IMPORTANT RECALL INFORMATION #80324

**SUBJECT: RECALL CAMPAIGN #80324
2008 JAMBOREE SPORT AND TIOGA RANGER 25G MODEL CLASS C
MOTOR HOMES - SEAT BELT ASSEMBLY**

**RECALL
BULLETIN:**
80324

SUBJECT:
Replace Two
Seat Belts in the
Wrap-Around
Booth Dinette

Figure 1

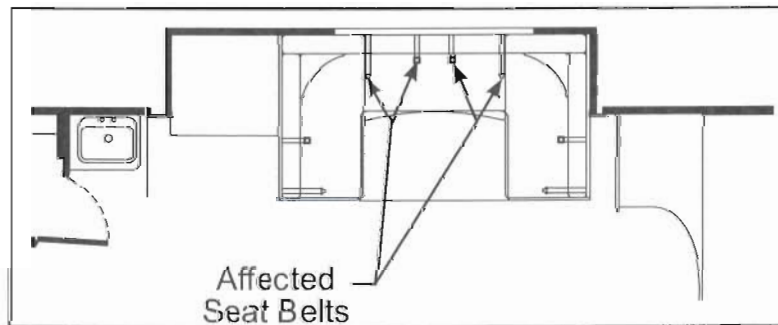
1. Remove the seat cushion from the center section of the wrap-around dinette booth to provide access to the seat belt anchor locations. Measure each affected seat belt section containing a buckle. Measure from the center of the anchor bolt, at the sidewall, to the tip of the buckle. If the length is between 22 to 26 inches, no further action is required for this Bulletin and the cushion can be replaced. If the measurement length exceeds 26 inches, complete the Correction procedure. See Figure 1.

Figure 2

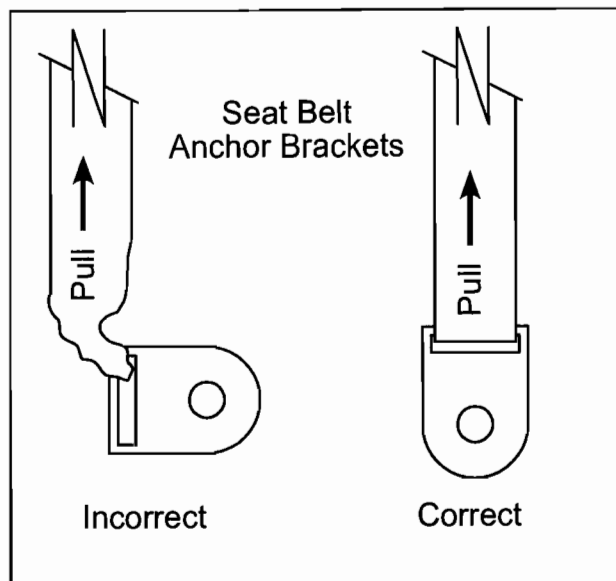
4. Remove the bolts securing the tongue and buckle seat belt sections for the two center seating locations of the dinette wrap-around booth. Retain bolts and lock washers for reassembly. Cut up and then discard the original seat belt sections.
5. Install the new seat belt sections, using original bolts and lock washers, according to the notes and stacking order from Step 3. Position the seat belt anchor brackets in-line with the seat belt pull direction. See Figure 2.
6. Torque the seat belt anchor bolts to 26 ft-lbs.
7. Replace the wrap-around dinette seat cushion.
